Metropolitan Development Commission Regional Center Hearing Examiner (September 26, 2024) Meeting Agenda

STAFF REPORT

Case Number	2024-REG-046
Address (approx.)	238 and 240 South Pennsylvania Street
Location	Center Township, Councilmanic District # 18
Petitioner	Boxcar Development, LLC., by Timothy E. Ochs
Zoning	I-3 (FF) (TOD) (RC); CBD-2 (FF) (TOD) (RC) (pending)
Request	Regional Center Approval for provide for a three-story entertainment venue.

SITE PLAN - SCALE: 1" = 20'-0"

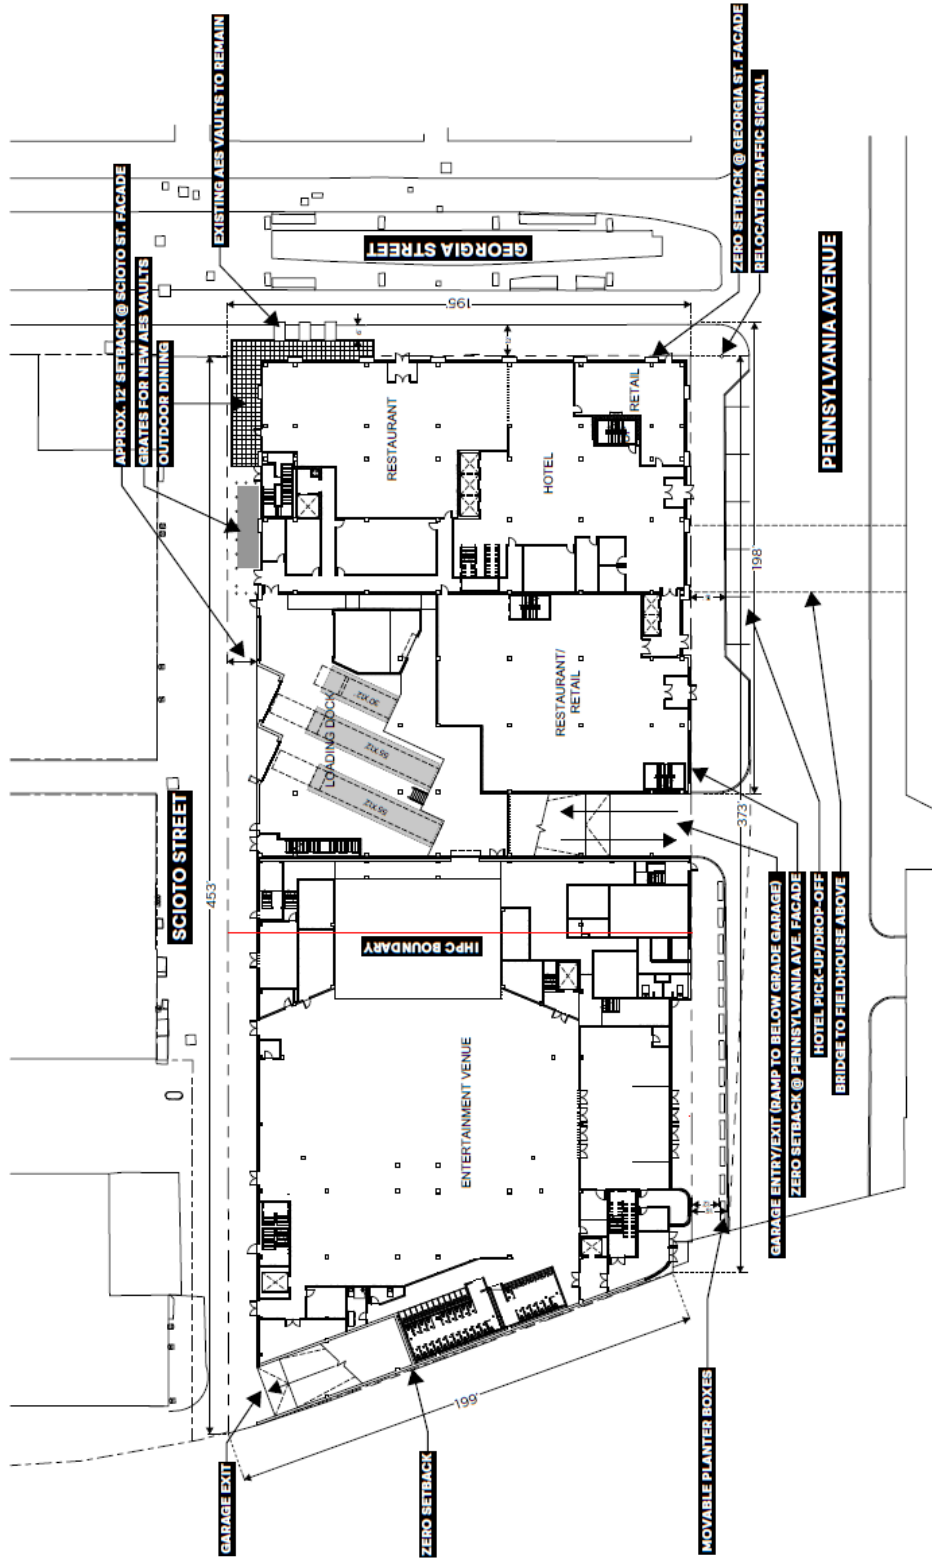
1. The façade north of the entrance to the facility would comprise of a brick wall, with a design feature into the brick in an attempt to help break up the long blank wall along the street frontage. However, the proposed canopy that is proposed over the entrance, if extended 10-20 feet further north onto the brick façade would assist further in breaking up this façade wall, plus provide weather protection prior to the entrance to the facility. Guidelines CA 1.2.1, CA 1.3.2, CA 2.1.1, CA 2.1.2, CA 2.1.6, and CA 2.3.1 apply.

2. At the north end of the brick wall, a cut-out into the brick at grade level appears to indicate a hidden door to the facility. This needs to be clarified by the petitioner. Guideline CA 3.1.5 would apply.

3. A lighting plan was not submitted to the file to identify the location of lighting standards or fixtures. Additionally, a photometric plan has not been submitted to the file. A photometric plan should detail light standards and photometric levels for the site and at each entrance. Lighting must be provided at each entrance and must be dusk to dawn. Only full cut and shielded light standards are permitted with minimum foot-candle power outlined in CA 4.3.2 and CA 4.3.3. Pedestrian areas and entries must be lighted for safety (CA 3.1.3 and CA 4.3.1). A lighting plan should be submitted prior to the hearing to ensure compliance with these requirements. If such a plan is not available, a detailed lighting plan shall be submitted and subject to planning staff review and approval prior to issuance of an Improvement Location Permit.

Staff would **recommend approval** of the Regional Center Approval petition, upon submission of the expected plans or a commitment to provide those plans, subject to the following conditions:

1. The Summary items shall be met.
2. All signage within two years of MDC approval requires planning staff review and approval. After the two-year period, a new Regional Center Approval petition would be required for review and subsequent approval of any proposed signage.
3. Address numerals shall be installed on the building façade (CA 2.5.8) prior to occupancy of the building.

Option 1B, with a mural – West (rear) elevation

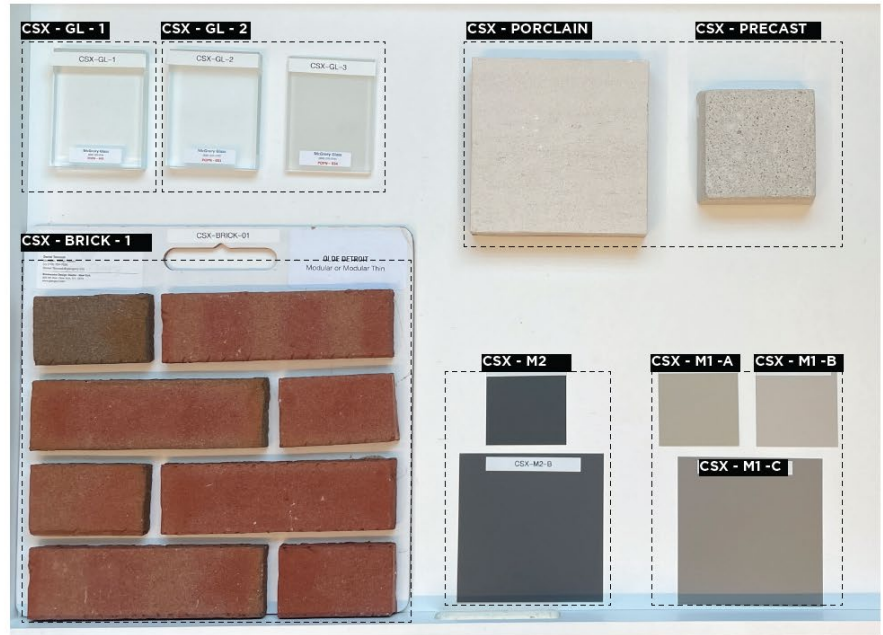
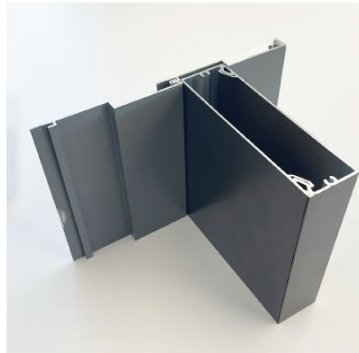
ADV	US 1.5.1 – Support for the arts is recommended to be integrated into the design of every new public and new commercial project with a floor area over 50, 000 square feet in size or having a construction cost of over \$1,000,000.	Satisfied with Option 1B	
ADV	US 1.5.2 – Public Art is recommended to be integrated with all new public institution and government construction projects greater than \$1,000,000 in value. Public Art is art that is located on public property and/or integrated with public construction projects. Public Art can include all forms of original works of art, exterior or interior, which are accessible to the public during normal hours of operation.	Satisfied with Option 1B

REQ	<i>US 1.5.3 – All permanent installations of art located in the Public Sphere or Quasi-Public Sphere shall be constructed of durable materials, not interfere with public safety, and be free of advertising. The installation shall provide access for as many individuals as possible (the provision of access for the mobility, hearing, and vision impaired is encouraged), consider public safety and liability issues; consider vehicular and pedestrian traffic patterns; consider the relationship to architectural and natural features, landscape design, environmental impact, and future plans for the area. Petitioners are encouraged to develop a long-term maintenance program for all permanent installations.</i>	Satisfied with Option 1B
REQ	<i>US 1.5.4 – All temporary installations of art shall not interfere with public safety and be free of advertising. Petitioners are encouraged to develop a long-term maintenance program for any such installation that uses recurring temporary or non-durable elements (such as flags or banners).</i>	Satisfied with Option 1B

ADV	<i>US 1.5.5 – Large scale installations of landscaping (environmental art), urban graphics or art consisting of dispersed components are encouraged. Projects will be reviewed for compatibility with these guidelines.</i>	Satisfied with Option 1B
